MFN 06-232

**Subject: Response to Portion of NRC Request for Additional Information
Letter No. 31 Related to ESBWR Design Certification Application –
TRACG Application for ESBWR ATWS – RAI Numbers 21.5-1, 21.6-
5, 21.6-6, 21.6-9, 21.6-33, 21.6-39, 21.6-40, and 21.6-47**

Response to NRC Request for Additional Information

PIRT Ranking of ESBWR Suppression Pool Equalization Line

Figure 1: RPV and Drywell Water Levels for BDL Break (12 hours)

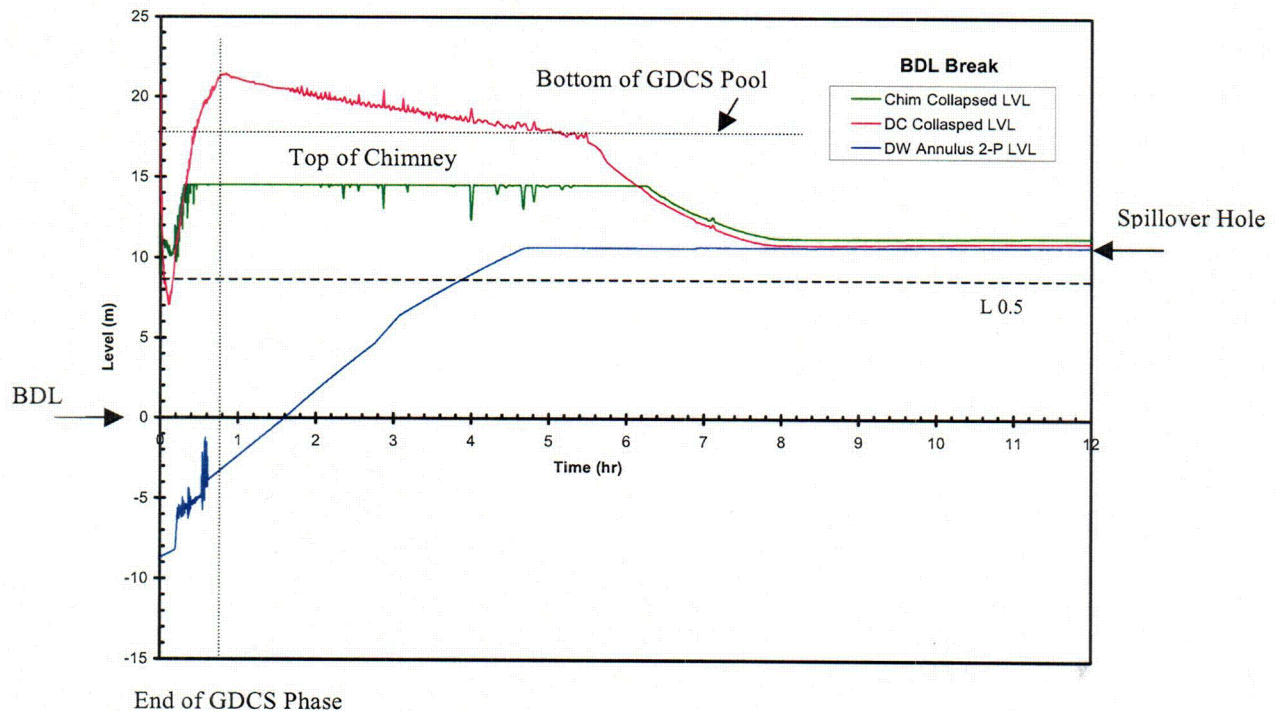
The NRC SER approving NEDE-33083P, TRACG Application for ESBWR, Confirmatory Item 1 stated that an appropriate long term cooling PIRT must be provided at the design certification stage. ESBWR DCD, Tier 2, Tables 6.3-7 through 10 indicate that the reactor pressure vessel (RPV) level will remain above Level 0.5 for the feedwater line break (FWLB), main steam line break (MSLB), gravity driven cooling system line break (GDLB), bottom drain line break (BDLB) and, therefore, the suppression pool equalizing line valves are not expected to open. GE submittal MFN 05-096, states that a long term PIRT will be provided. GE submittal MFN 05-105 provides a long term PIRT which lists the equalizing line (EQ) importance as "N/A". GE submittal MFN 05-109 indicates in Table 2, "Containment/LOCA long term PIRT," that the equalizing line (EQ1) friction is ranked "High". Clarify the importance of the equalizing line for long term cooling in the DCD and describe appropriate testing (i.e., qualification testing and inspection test analyses and acceptance criteria (ITAAC)).

As stated in the DCD Tables 6.3-7 through 10, the equalization line valves are not expected to open for a Loss of Coolant Accident (LOCA) resulting from a break in any of the lines in the current ESBWR design. Figures 1, 2, 3 and 4 (from MFN 05-105) show the downcomer level response for the first 12 hours following a bottom drain line break, feedwater line break, GDCS line break and main steam line break respectively. The figures show that the downcomer water level stabilizes at an elevation well above the elevation of the L0.5 trip (1 m above top of active fuel and approximately 8.5 m above the bottom of the RPV). The lowest level in the long term occurs for the GDCS line break, which still has more than 1 meter margin to L0.5. This is the consequence of two changes in the current design relative to the design analyzed in NEDE-33083P: a larger GDCS pool volume and smaller lower drywell volume.
